403 DEXTER AVE N

#3024377

DESIGN RECOMMENDATION MEETING

DECEMBER 7TH, 2016

LANDSCAPE PLANS - STREETScape & ENTRY COURT

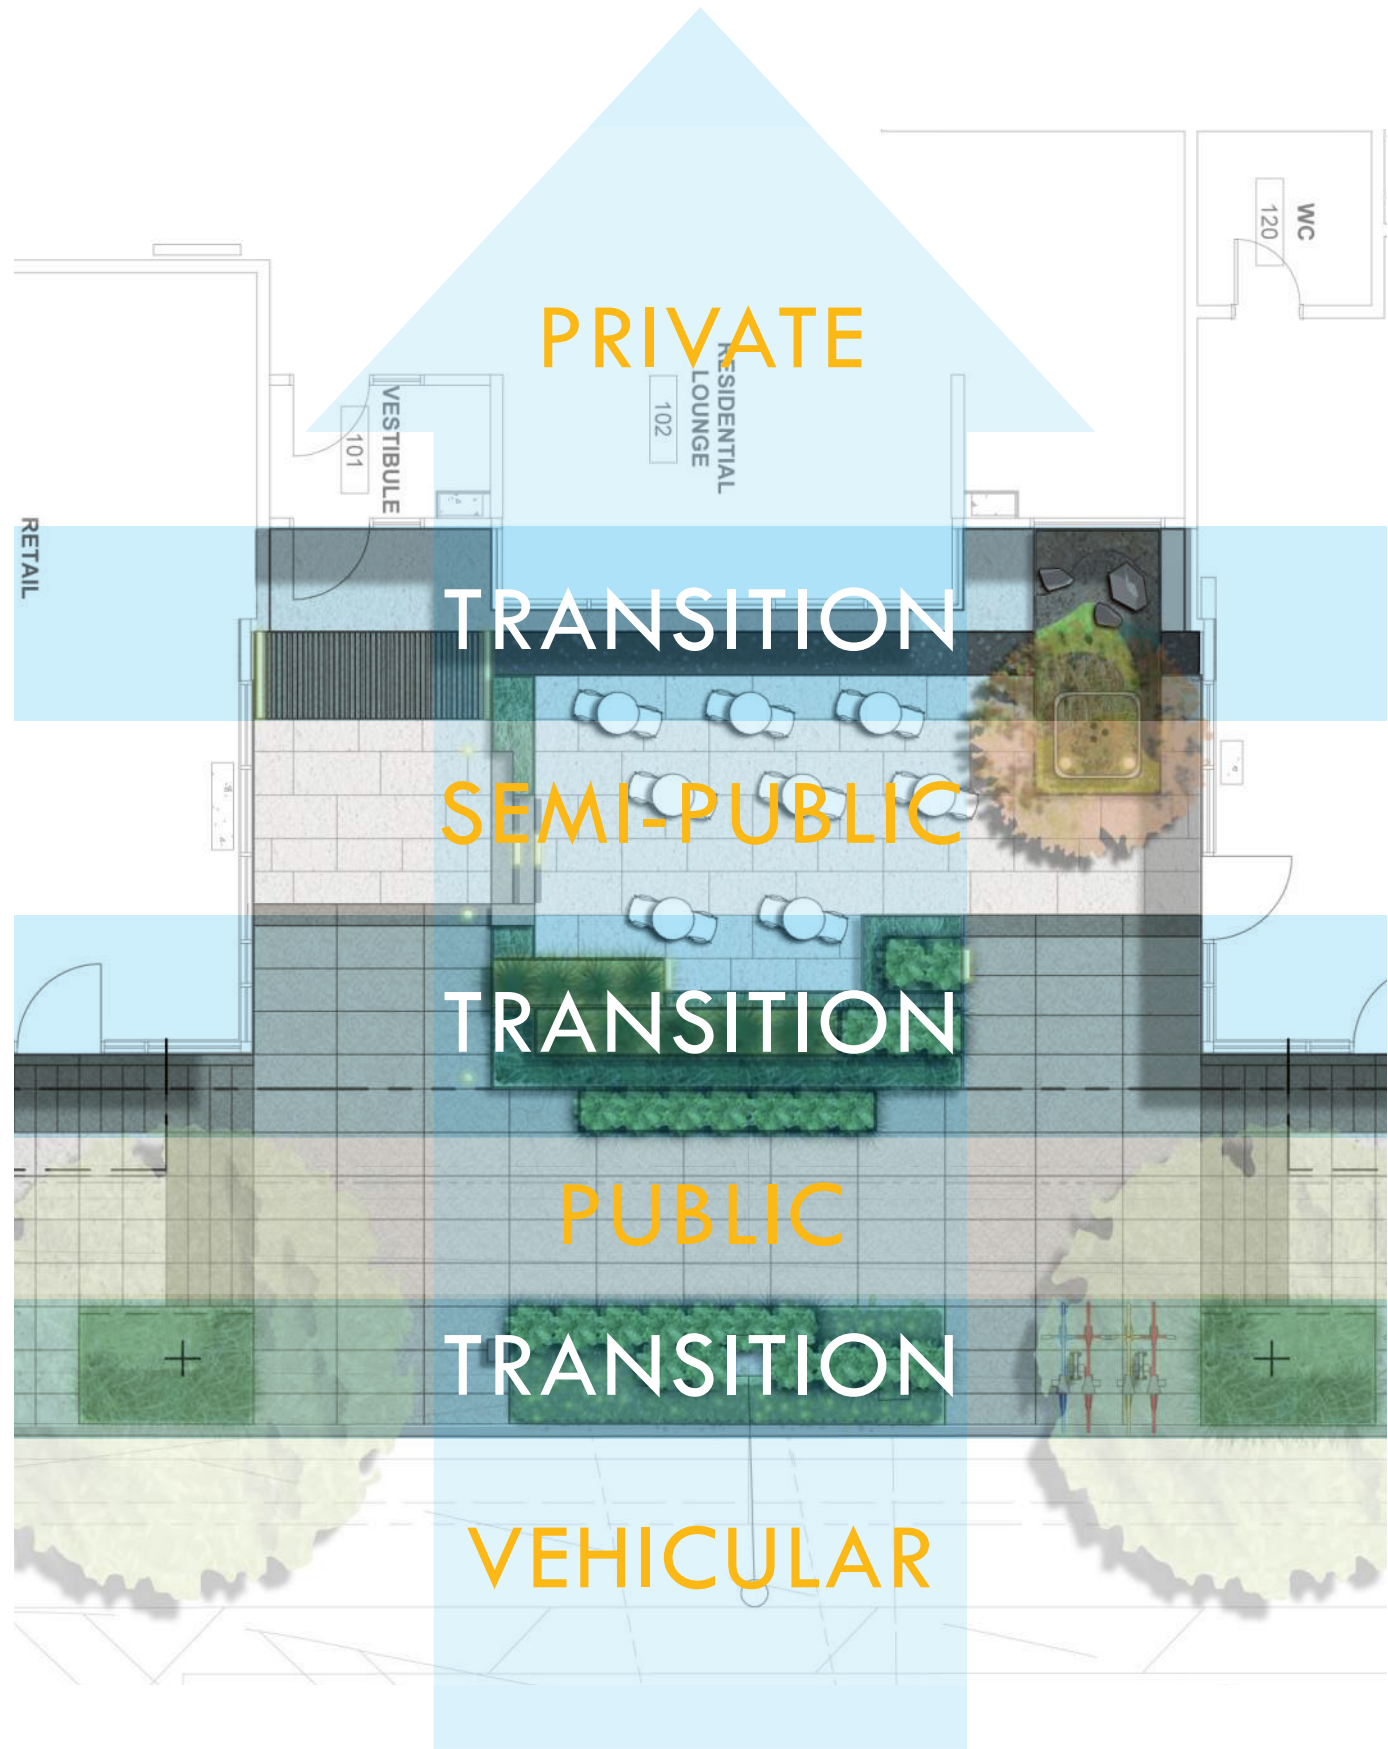
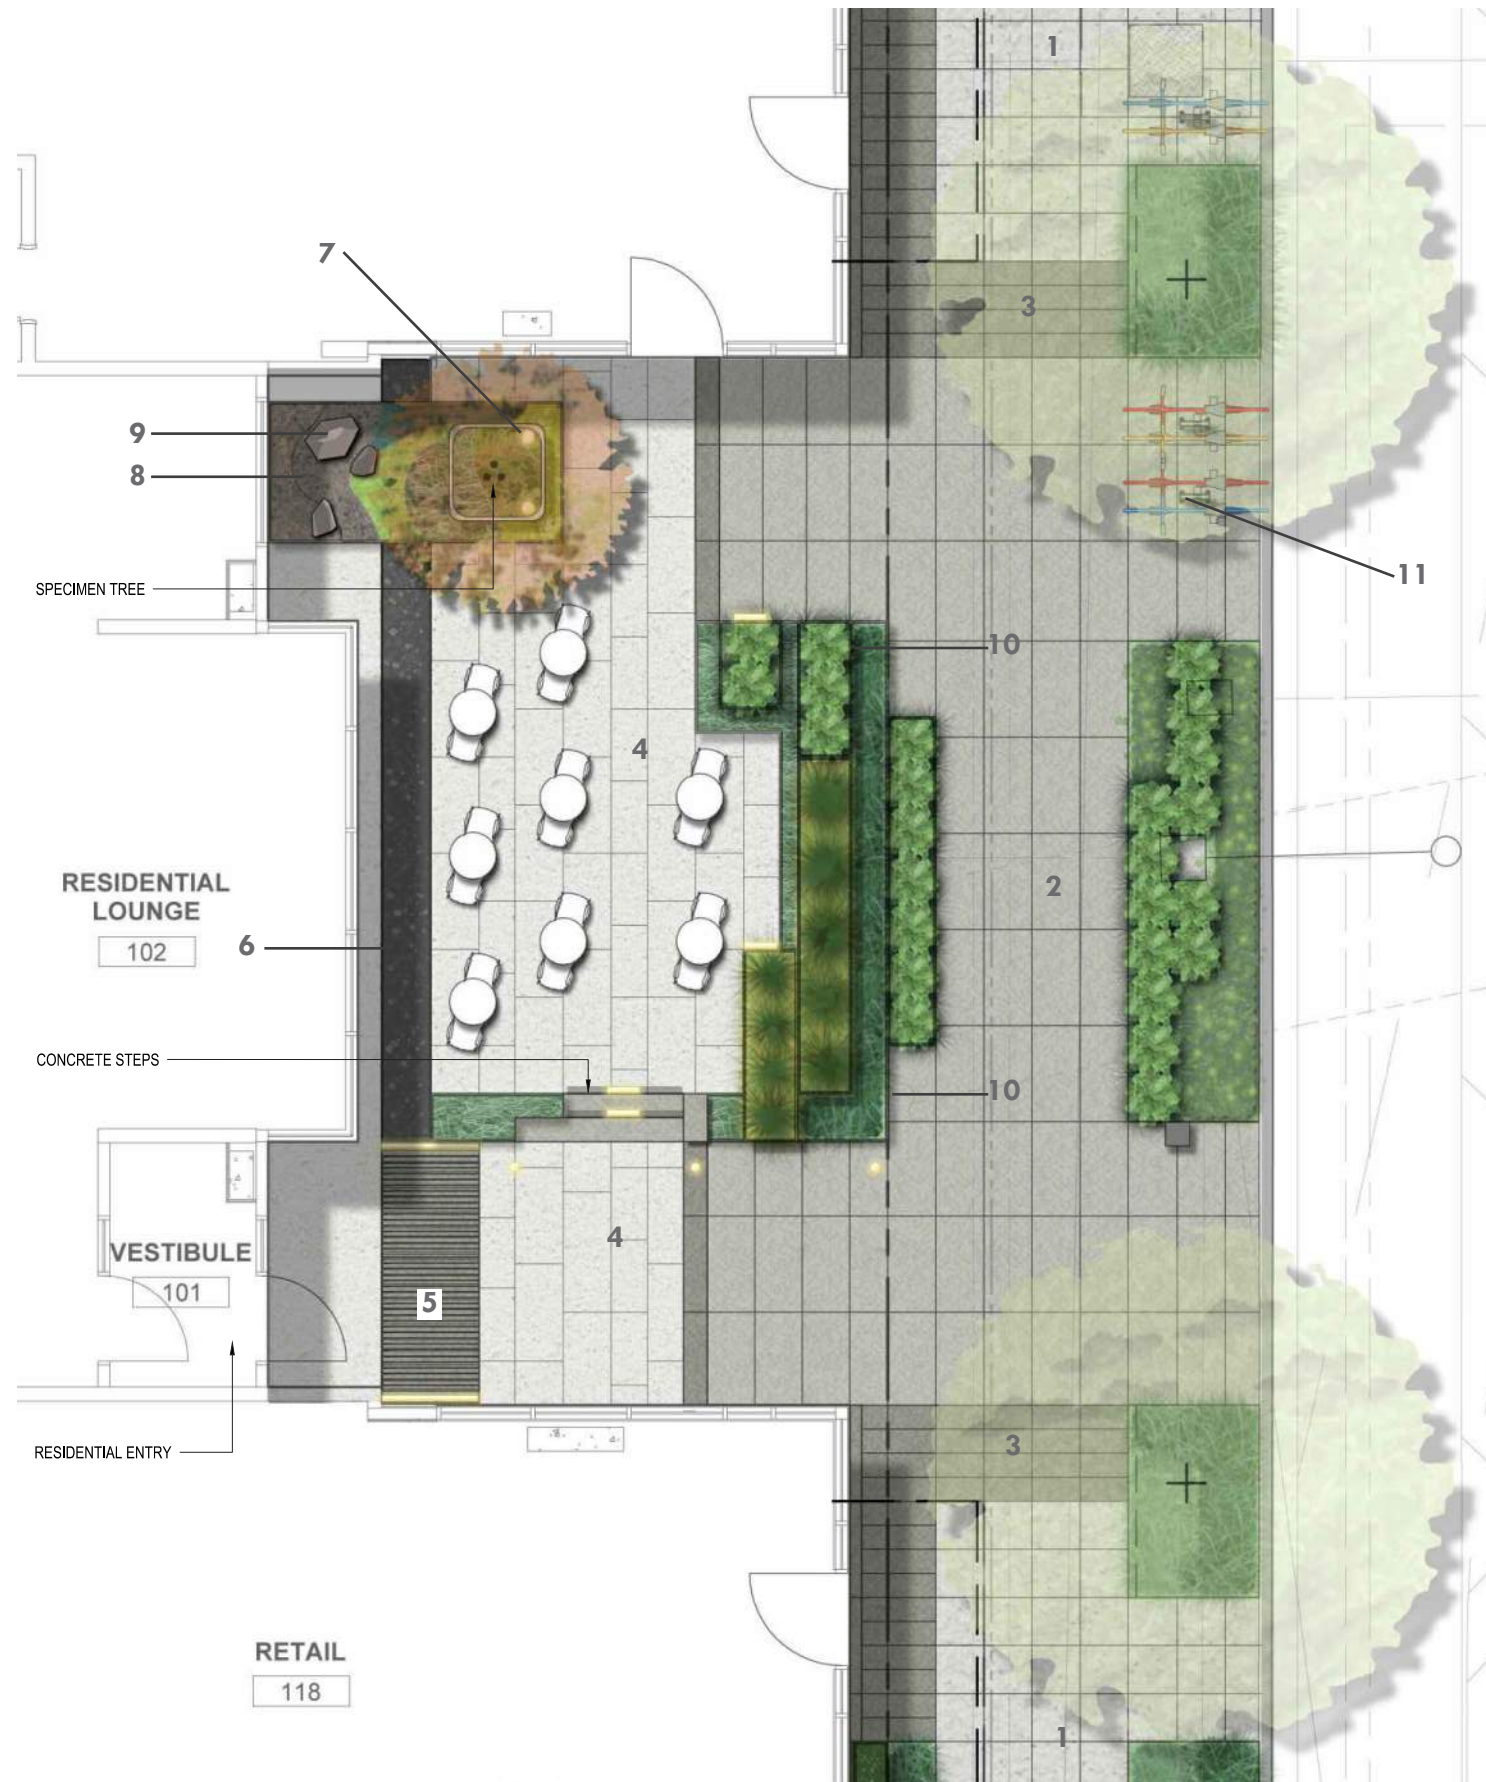
- The Board encouraged developing the concept of the courtyard and noted the potential for a play on a cavern concept. The Board recommended exploring the placement of site furniture and site walls to reinforce the design concept.
- The Board supported the proposed pavement treatment and recommended expressing the courtyard space with accent patterns and/or varying paving.
- For the streetscape, the Board agreed the breaks in the planting are discontinuous and recommended softening the building and adding more landscaping along the streets edge. The Board requested adjacent perspective views of the streetscape for the next meeting.

- The proposed design of the courtyard seeks to create a refuge for the building tenants, with a layering of landscape and site furniture to buffer the business of Dexter beyond.
- The proposed design utilizes a variety of paving to delineate use, entry, and to define space.
- The proposed design provides the maximum amount of landscape at the street edge feasible, while maintaining pedestrian access for the residential lobby and retail spaces, as well as providing for utilities.

SOUTH FACADE MODULATION

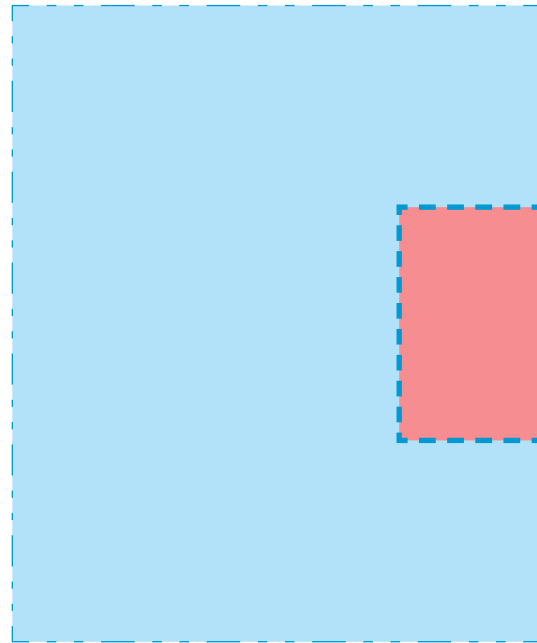
- The Board stressed the importance of being rigorous about materiality in order to successfully convey the design concept and recommended thoughtful application of materials, complimentary to the Modera.
- The Board unanimously supported the south façade corner glazing and recognized that the corner glazing and the break in the massing minimizes the blank wall condition along the south façade.
- Acknowledging the southwest corner will be highly visible, the Board encouraged the applicant to continue to think of it as a visible façade and agreed the same level of care as the other frontages should be considered.

- The proposed design provides a simple yet lively facade, with a rigorous material concept that is applied around the entirety of the building.
- The modulation of the south facade has been retained, and continues to allow for corner glazing and relief from what would otherwise be a blank wall condition.
- Because of its visibility from the public realm, the proposed design applies the same rigorous cladding approach to the southwest corner as seen on the Dexter facade.

NORTHWEST CORNER SETBACK

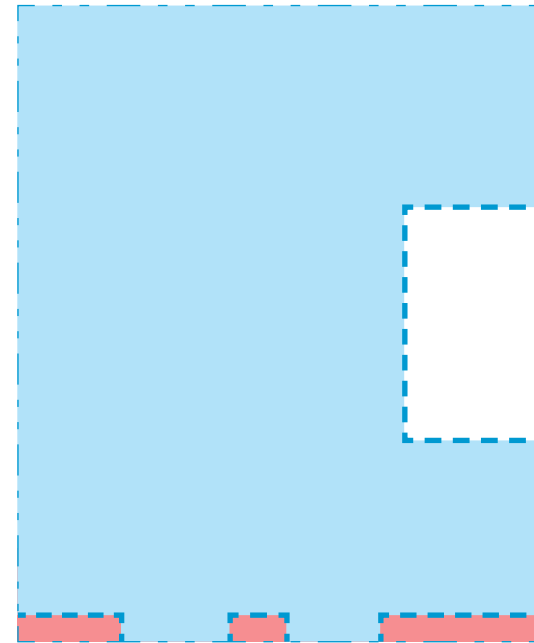
- The Board strongly supported the open space location and recognized it as a great benefit to the public realm and good urban design
- The Board acknowledged the adjacent Modera building open space and discussed if setbacks should be explored for the northwest corner. Ultimately, the Board agreed setbacks at this location should not be provided at the cost of reducing the open space along Dexter and stated they would be open to setbacks if the current open space size is not affected.

- The overall open space approach remains unchanged. However, the proposed design has been able to incorporate building setbacks at the northwest corner, without reducing the open space along Dexter.
